**Memorandum**

TO: Planning and Environmental Commission

SUBJECT: A request for final review of an amendment to a conditional use permit, pursuant to Section 12-9C-3, Conditional Uses, Vail Town Code, in accordance with Title 12, Chapter 16, Vail Town Code, for an existing healthcare facility, amending the development plan to allow for the reconstruction of the east wing, including healthcare facilities, ambulance district facilities, heliport building and associated structured parking located at 180 South Frontage Road West (Vail Valley Medical Center)/Lots E, and F, Vail Village Second Filing, and Lots 2E-1 and 2E, Block 1, Vail Lionshead Filing 1. (PEC17-0022)

Applicant: Vail Valley Medical Center, represented by Davis Partnership and  
Braun and Associates

A diagram of the proposed site plan for the South Frontage Road from the Lionshead Parking Structure to the Scorpio Condominiums is shown below:

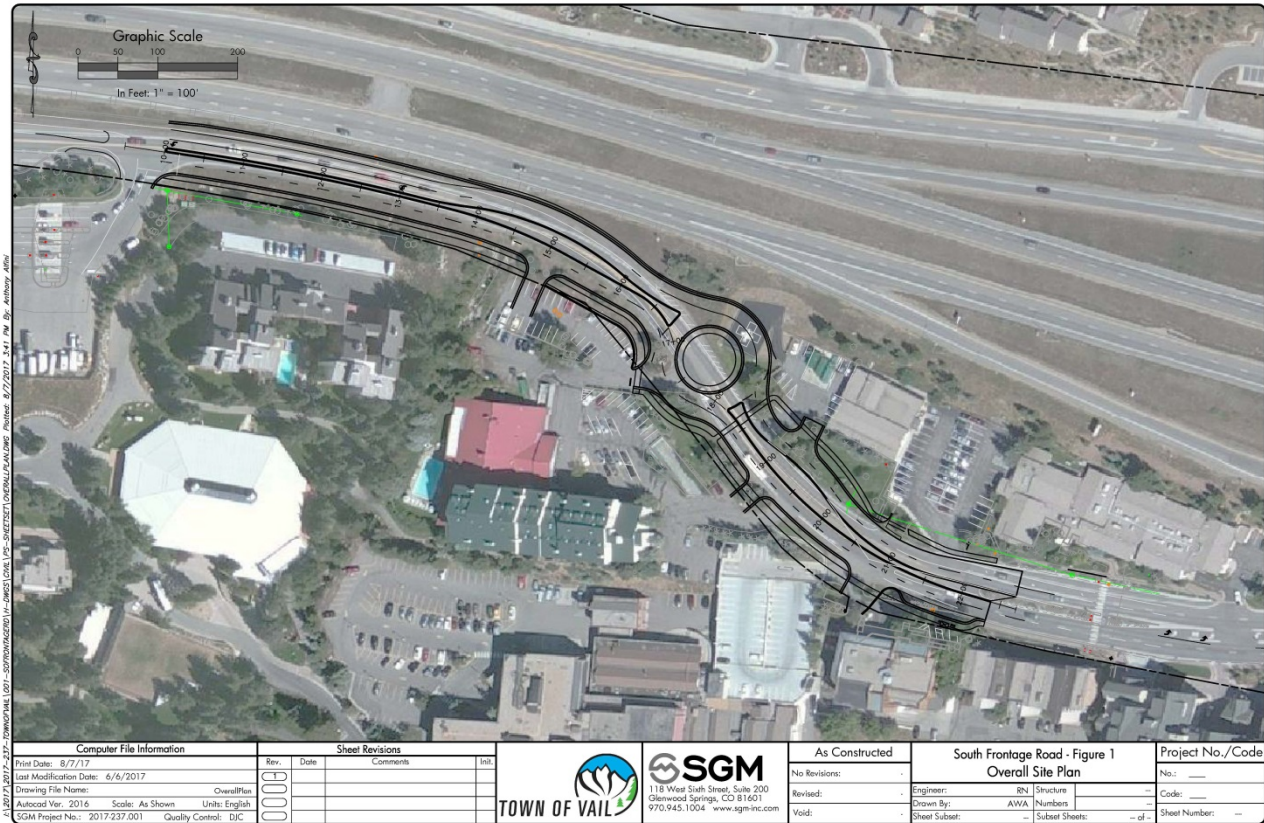
The applicant has worked closely with the Town of Vail Public Works Department to design improvements to the VVMC frontage that will accommodate the anticipated roundabout and expansion of the travel way to four lanes. The Master Plan discusses the extensive study, with over ten alternatives, that has taken place to determine the most appropriate and efficient design solution for the South Frontage Road between the Lionshead Parking Structure and the eastern end of the VVMC campus. This design includes a four way travel section proceeding east from the Lionshead Parking Structure, transitioning through a two lane roundabout just west of the existing municipal building's east parking/recycling area, and culminating with a four lane section, including turn lanes, that joins the exiting four lane section in front of the Scorpio Building. Also included is the relocation of the existing bus stop from within the travel way to a pull-off area, a \$15,000.00 contribution to a new shelter in the vicinity of the MPB frontage and an eight (8) foot snow-melted sidewalk along the frontage. Due to constraints on the proposed boilers, snow melt for the portion of the sidewalk in front of the MPB is proposed to be delayed until the anticipated redevelopment of that site. At this time, the town is recommending that the surface material be concrete unit pavers consistent with the sidewalk to the east and the anticipated sidewalk to the west. The applicant has expressed concerns related to safety for patrons, especially those requiring walkers, crutches or other assisted devices. Staff is supportive of investigating other decorative surfaces that may provide greater safety but is unsupportive of a non-decorative,

uncolored concrete finish. This design feature will be addressed further during the DRB review of this project.

The master plan includes this diagram as an illustrative guide to the streetscape:

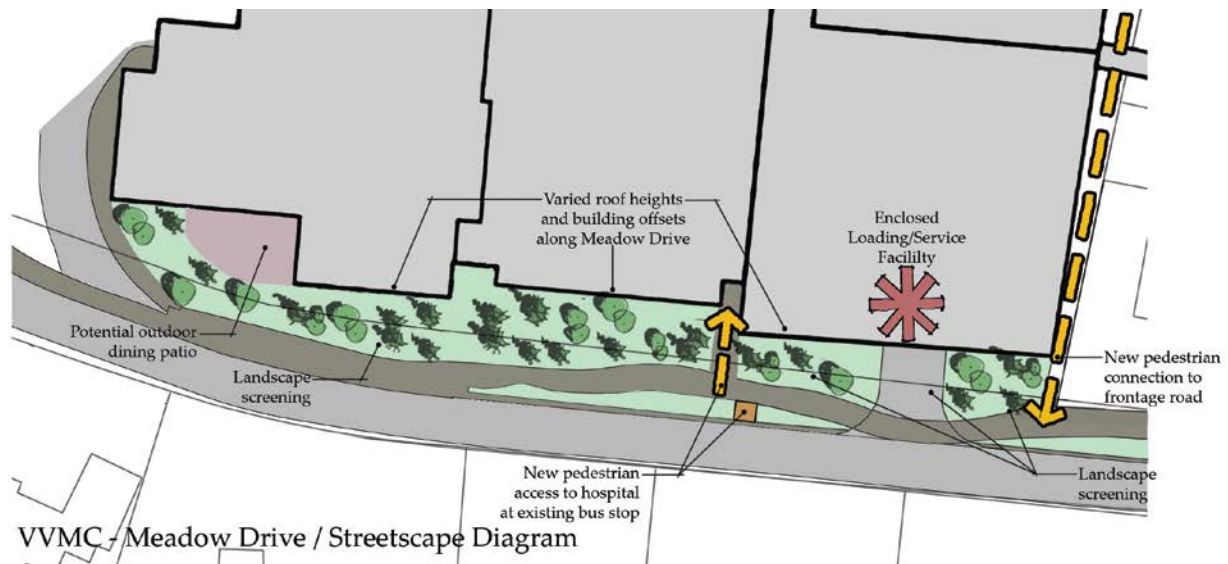
Although the elevation does contain a public building entrance, staff has expressed concerns that the loading dock uses may not have been effectively masked in previous submittals, resulting in a somewhat industrial feel in this residential neighborhood. In response the applicant has proposed architectural revisions to the loading dock doors and increased landscaping to soften the building's interaction with the public realm.

The building's proposed setbacks from the southern property line vary from zero to four feet, leaving minimal locations for landscaping to soften the building's pedestrian edge. Although recognizing the site constraints and the internal programming that dictate many dimensions, staff has expressed concerns that this lack of landscaping may read as too urban and somewhat inconsistent with the neighborhood. In response the applicant has augmented the landscape plan with additional planting areas and taller plant species.
